RFP for Pump Station #1 & #2 Rehabilitation

November 15, 2013

Addendum 1: Revisions to Construction Plans and Specifications

The City of St. Pete Beach is releasing the following addendum to Pump Station No. 1 & 2 Rehabilitation Plans.

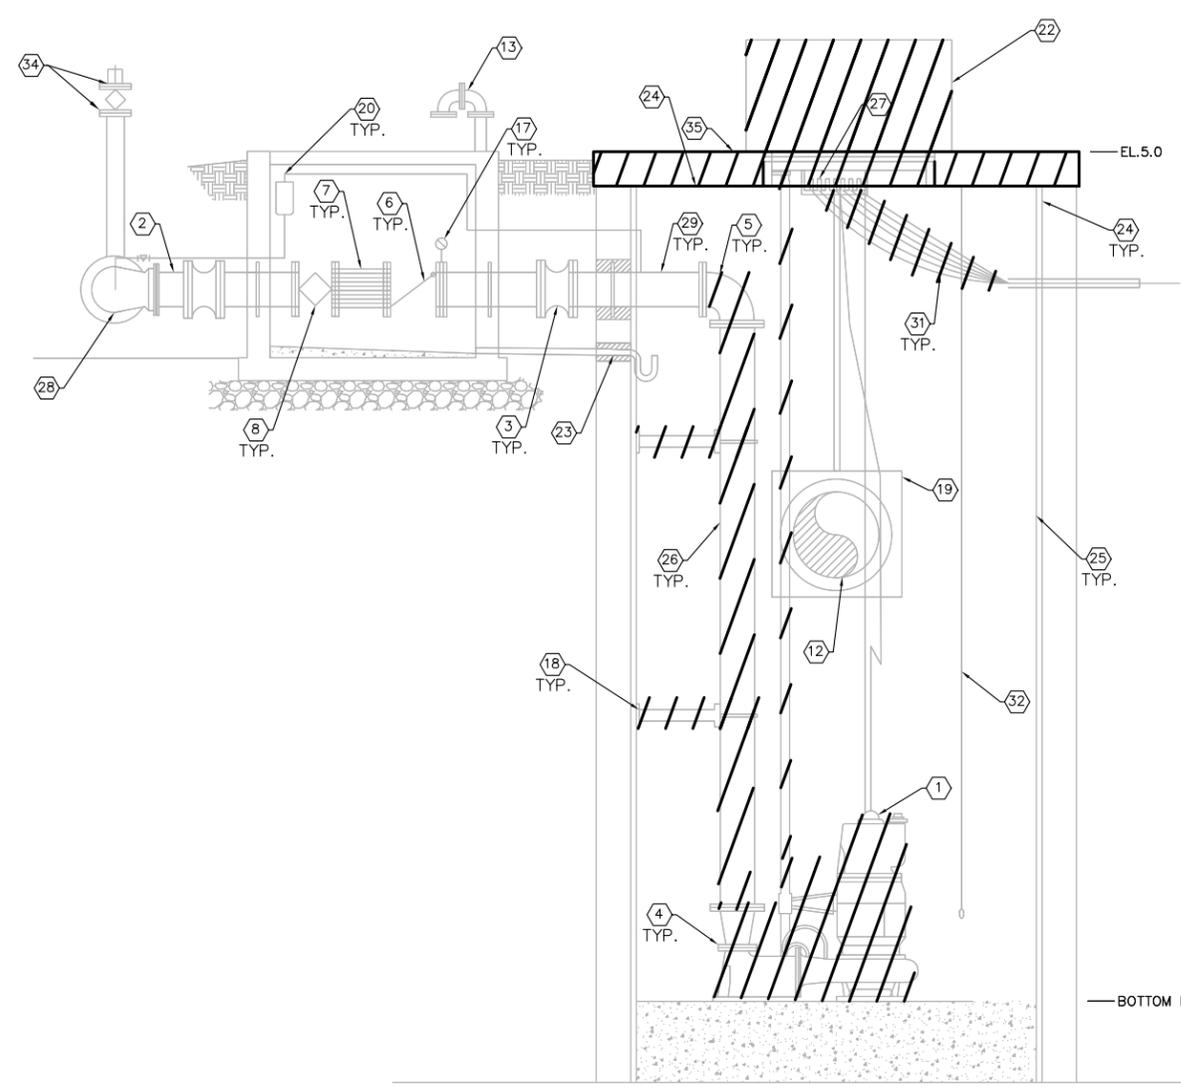
- G-0.1 – Cover Sheet
- G-0.2 – Drawing Index and General Notes
- G-0.5 – Bypass Pumping Plan
- D-0.2 - Pump Station 1 Demolition Plan
- D-0.3 - Pump Station 1 North Wetwell Demolition Section – (NEW PLAN SHEET)
- C-0.2 – Pump Station 1 Site Plan
- S-0.1 – Pump Station 2 Wetwell Plan and Sections
- S-0.2 – Pump Station 1 Top Slab Plan and Sections – (NEW PLAN SHEET)
- S-0.4 – Structural Details
- M-0.2 – Pump Station 1 Plan and Section
- M-0.21 – Pump Station 1 North Wetwell Section – (NEW PLAN SHEET)
- E-0.4 – Pump Station 1 Electrical Site Plan
- E-3.1 – Motor Control Center & One-Line Diagram
- E-3.2 – VFD Wiring Diagram
- E-3.6 – Pump Station 1 VFD Schematics and Diagrams
- I-3.2 – PLC Wiring Schematics

DATE NOVEMBER 2013
 PROJECT NO. 148404000
 SHEET NUMBER **S-0.1**

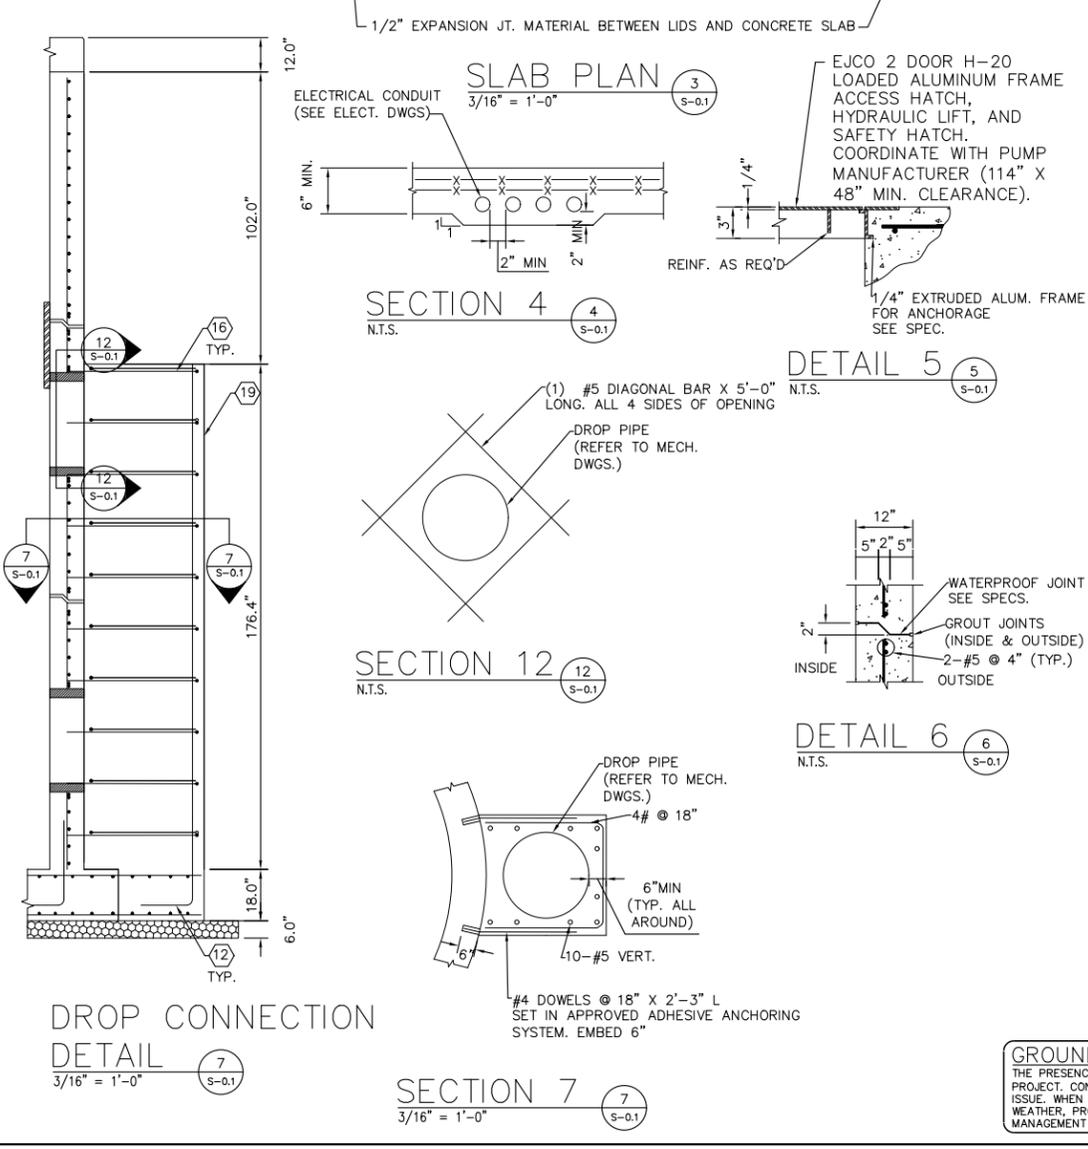
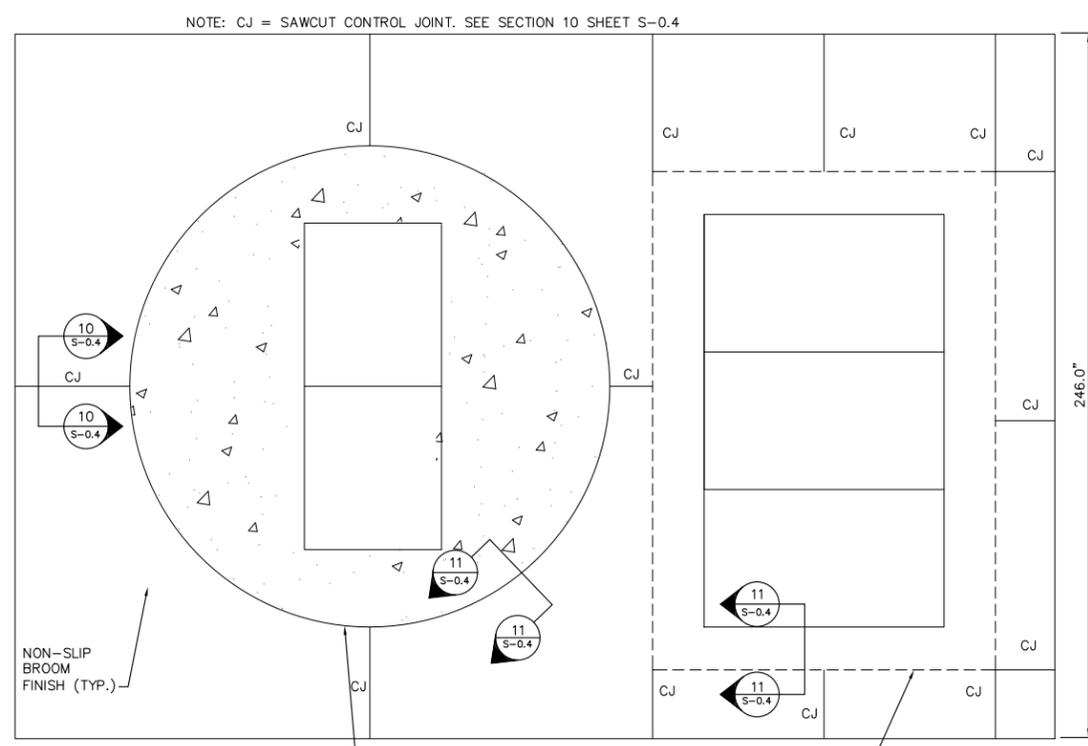
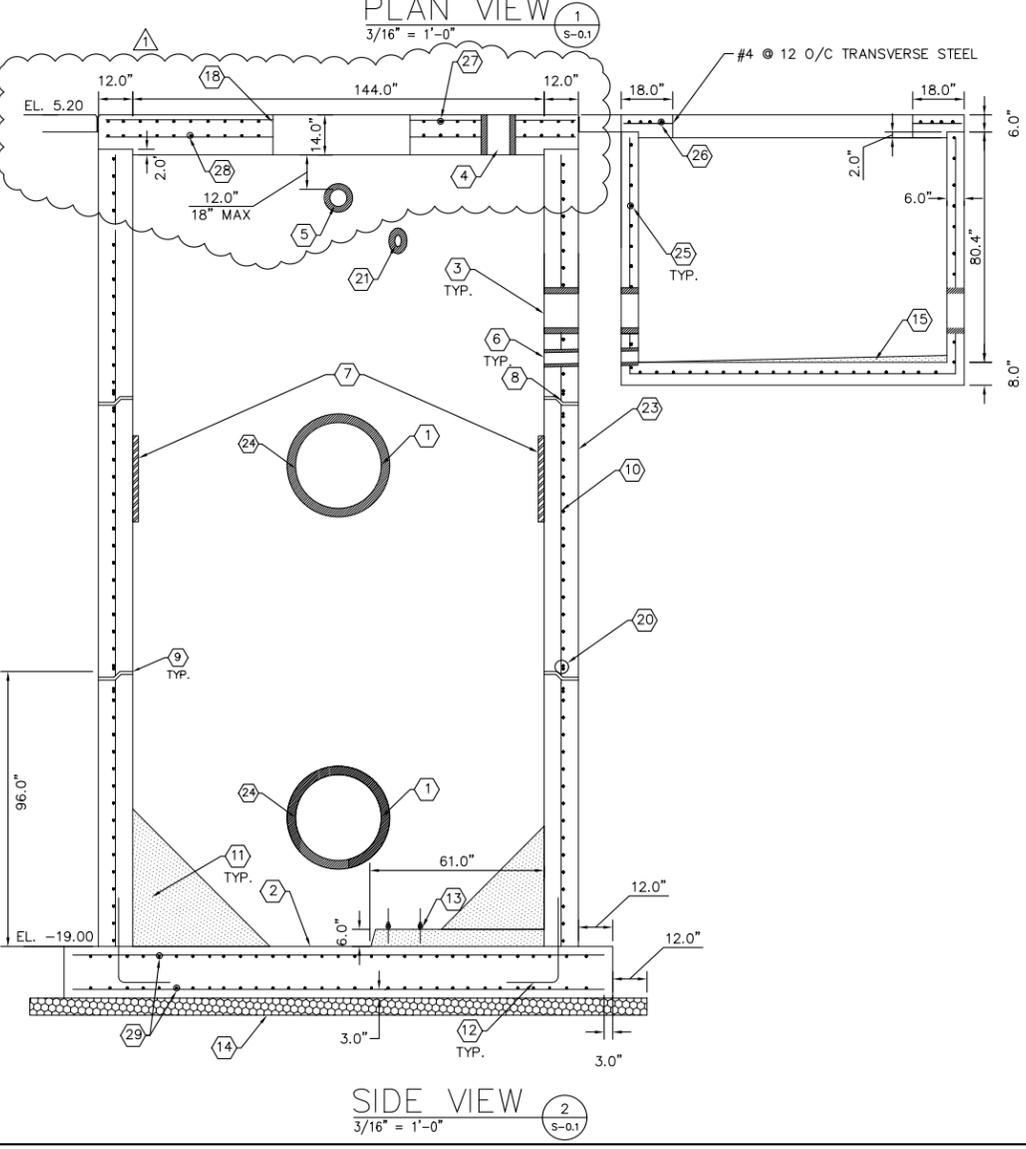
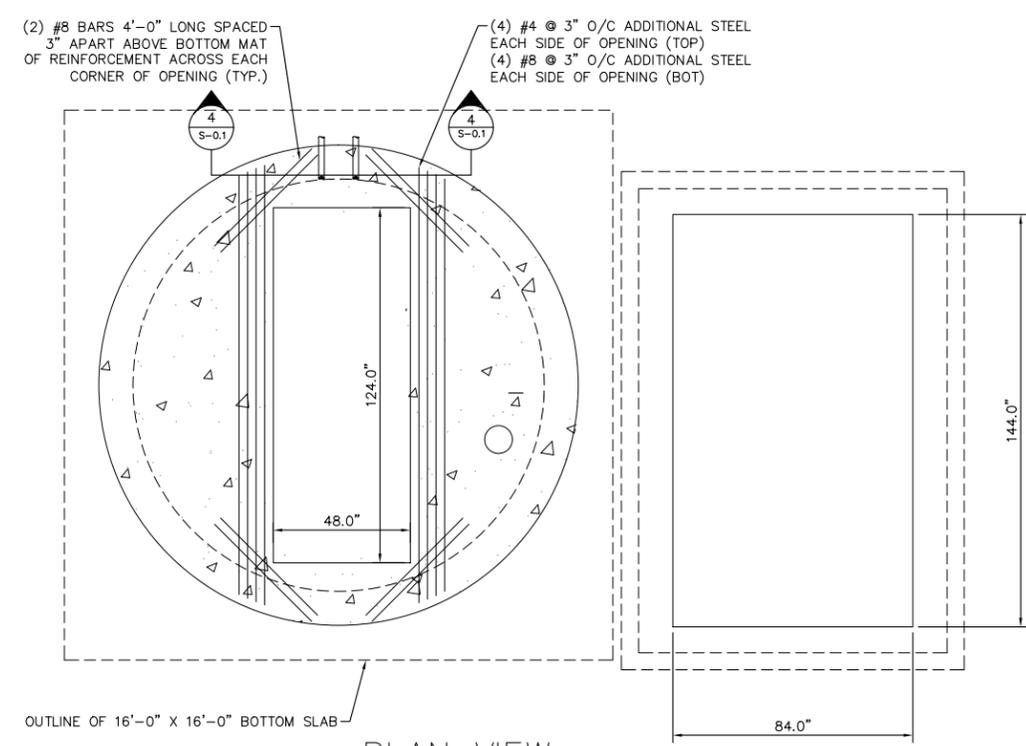
1. *Sheet S-0.1, Note 7, Cast-in-Place TLock PVC Liner on interior of station, can Argu or HDPE liner be used also?*
Response: Contractor must use a Cast-in-Place liner that meets the specifications set in “SECTION 23 – PVC LINER.” If Argu or HDPE liner can meet these specifications they can be considered an approved equal, however, the contractor must submit documentation prior to bid, for review and approval, to support that the alternate liner can meet the specifications.

**SOUTH WETWELL
 PLAN VIEW**
 3/16" = 1'-0" (1) S-0.2

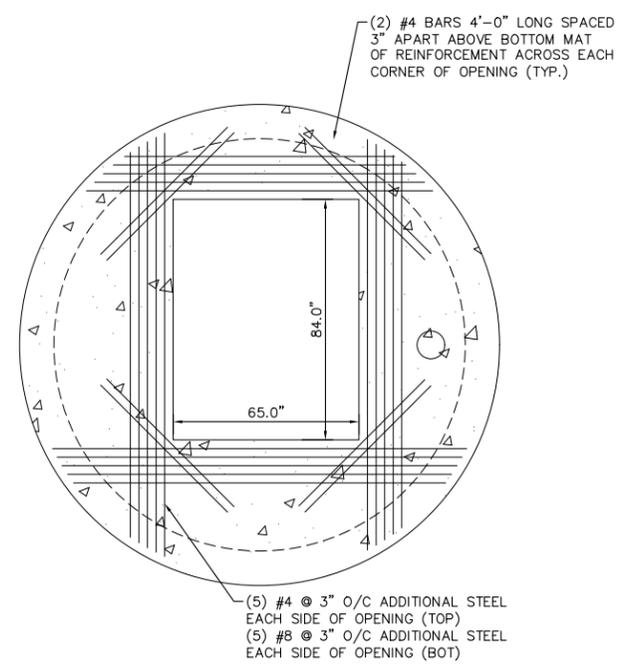
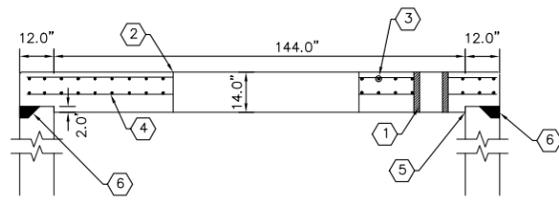
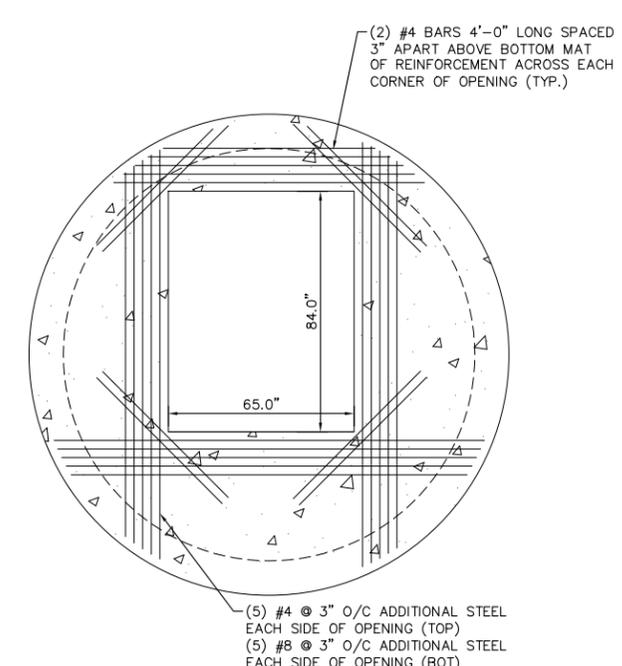
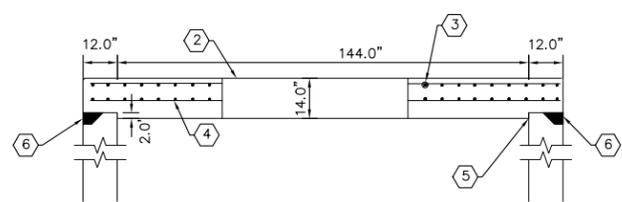
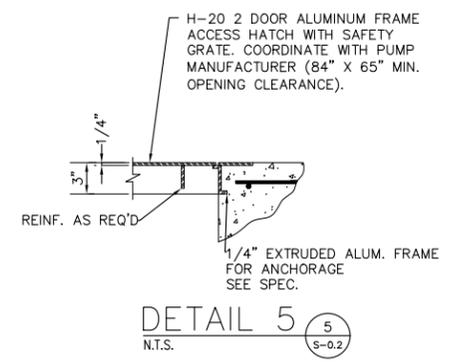
1. The Contractor shall supply and install the new hatches as indicated on drawing S-0.2 as issued in Addendum #1. The Contractor shall coordinate the size and opening location of the access hatch with the pump manufacturer. The Contractor shall take extra care during the removal of the existing lids at Station #1 as to not damage the wet well liners. If the liners or any other existing equipment, materials, or installations are damaged, the contractor will be responsible for replacement or repair.
